NOTICE AND AGENDA
Regular Meeting & Work Session to follow regular meeting
Idaho Springs Planning Commission
1711 Miner Street, City Hall
Wednesday, May 1, 2024 – 6:00 p.m.

A. Request for Amendments to the Approved Final Development Plan (FDP) for the Block 57 / Former Golddigger Field Mixed-Use Project

IDAHO SPRINGS
PLANNING COMMISSION STAFF REPORT

Meeting Date: Monday, May 1, 2024	**Page 1 of 5**	**Item:** **Request for Amendments to the Approved Final Development Plan (FDP) for the Block 57 / Former Golddigger Field Mixed-Use Project**
Presented by: Dylan Graves Community Development Planner

Proposed Building 2 South Elevation

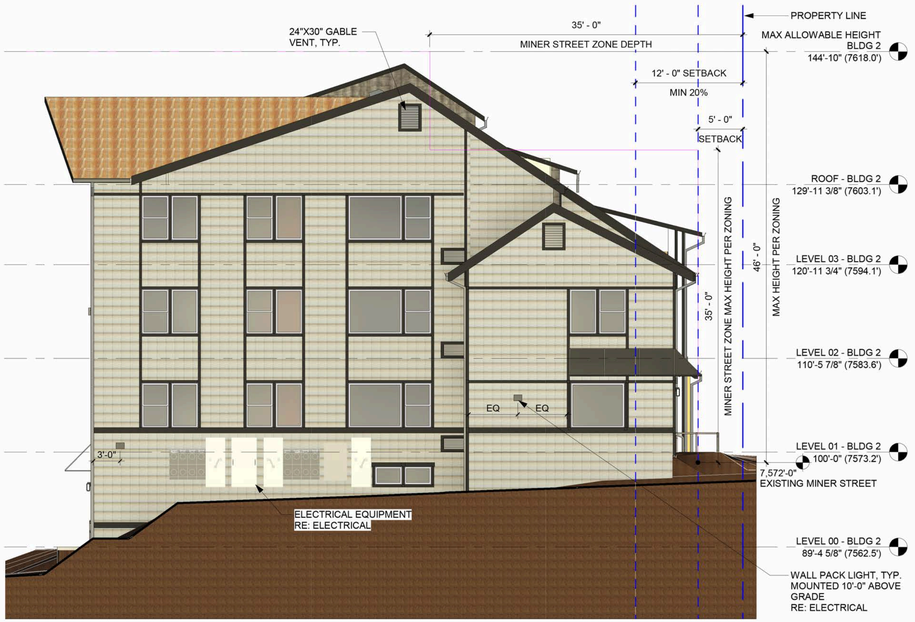
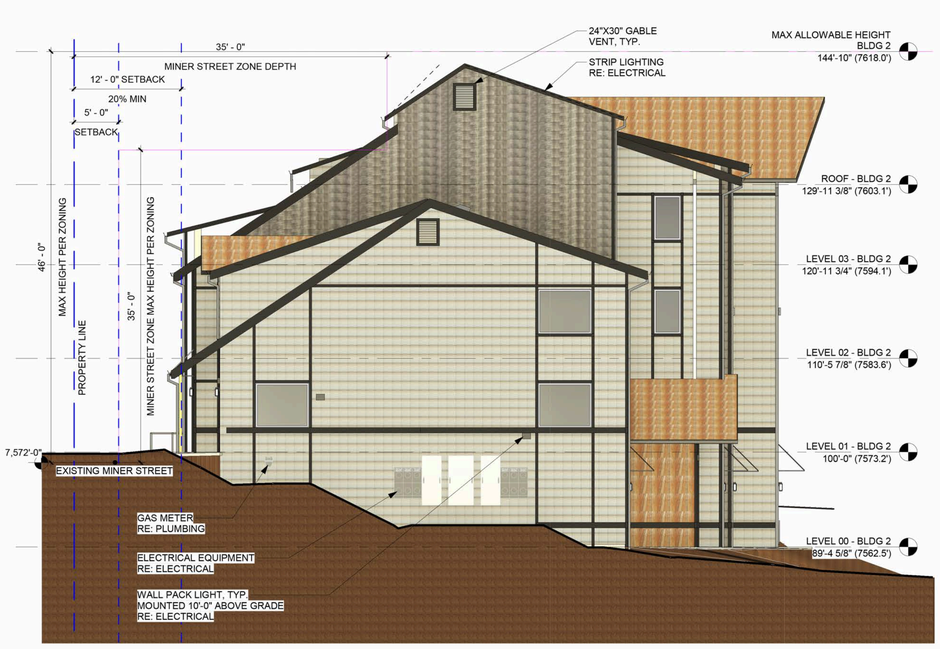
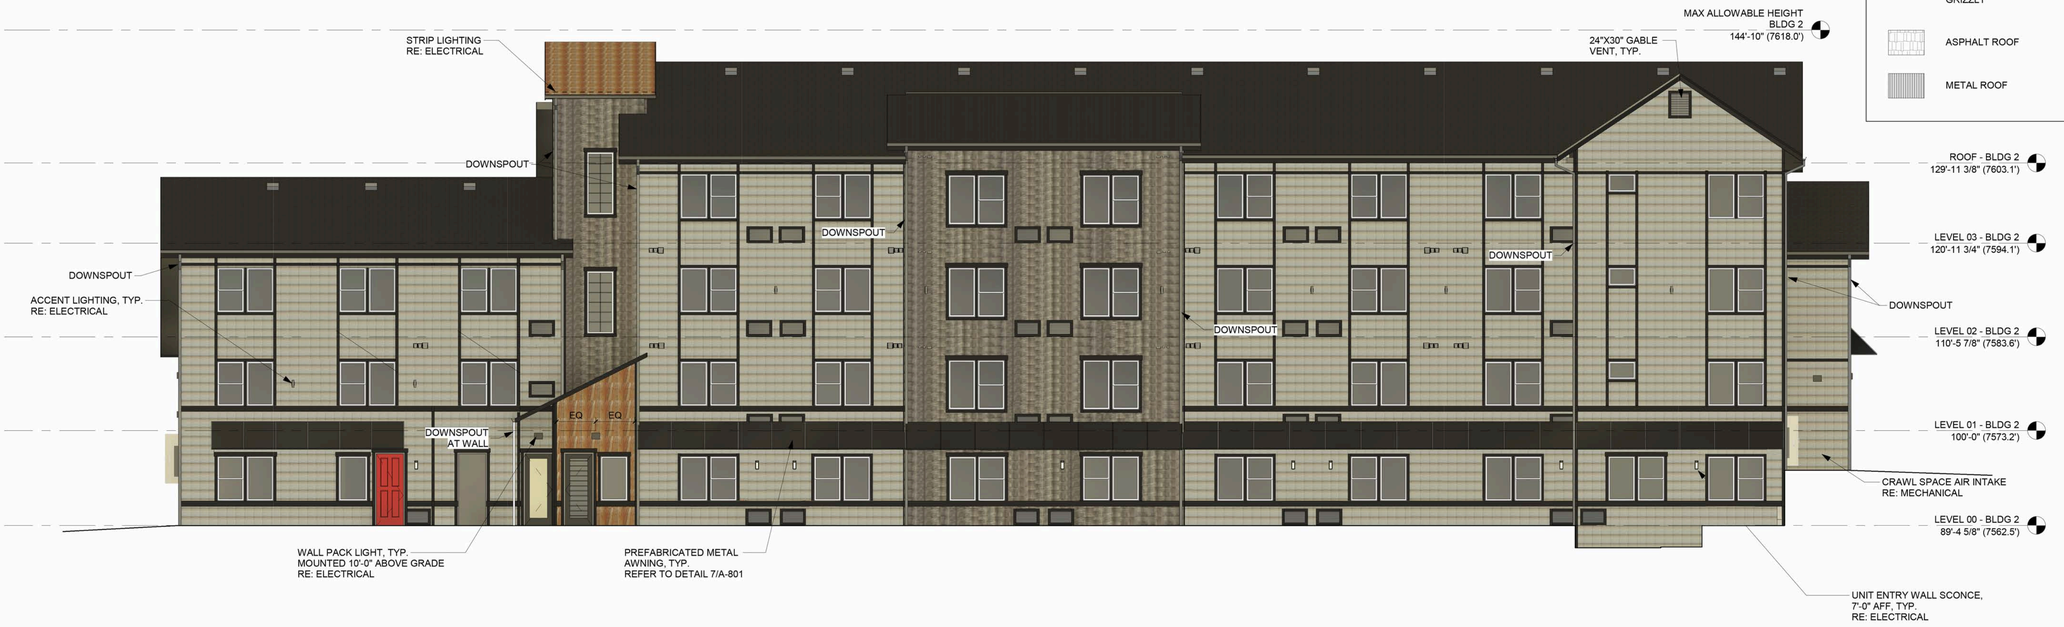
The requested revision modifies the Southern façades on Building 1 and Building 2 facing the approved parking lot for the development. The effect of the revision would be to replace the doors, as approved on the existing FDP, with windows. In association with this change, they would be removing the patios and walkways that were approved to allow pedestrian access to said door from the south parking lots. The units that would be impacted have access through the interior corridors of the buildings, which is proposed to remain unchanged.

Remove the exterior unit entrances, patio's and walkway to sixteen (16) units on Level 00 facing I-70. This desired change is based on the use of the interior space and security. Fourteen of the sixteen units are 450 SF studios. Due to the limited SF, we believe it is important to make as much of this interior space as usable as possible. The swing of the exterior door and subsequent entrance pathway into the unit affects the "living room" area of the apartment. By eliminating the door, it creates a much more usable "living room" area. Secondly, the exterior entrance directly to the parking lot, creates a potential security risk for these residents. By removing this entrance, all residents would enter through the locked corridor entrance. The corridor entrances will be locked at all times, accessed by either key card or physical key by the residents, which allows the Property Managers to control who enters the building.

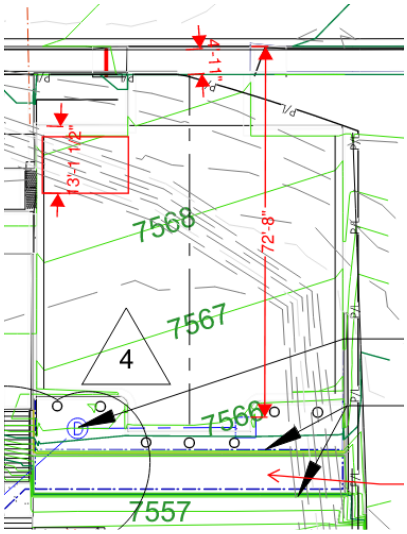
PARKING LOT REVIEW:
The engineering team has reviewed the northeast parking lot and does not find that it is in a feasible location for the size and accessibility requirements needed for the city.
The current parking lot is shown at 5.5% slope from front of lot to rear of lot. South of the lot there is a tiered 9' tall retaining wall that presents a challenge tying in to the wall along the property to the East along the adjacent property line.
After detailed level design was completed on the lot, there were some issues that arose. The first is the ADA requirement for both the walk crossing and stalls. This removes around 18' of parking lot that increased an already steep 5.5% slope to 7.25% slope. The second is the tie in location to the existing east sloped wall adjacent to the single family home. Lastly is the overall safety concerns with a 9' tall wall.

With the removal of this wall, grading along the adjacent property, relocation of parking stalls to still exceed parking requirements, and more green space for storm runoff can all be achieved. We believe this is a better solution for the development and the surrounding community.
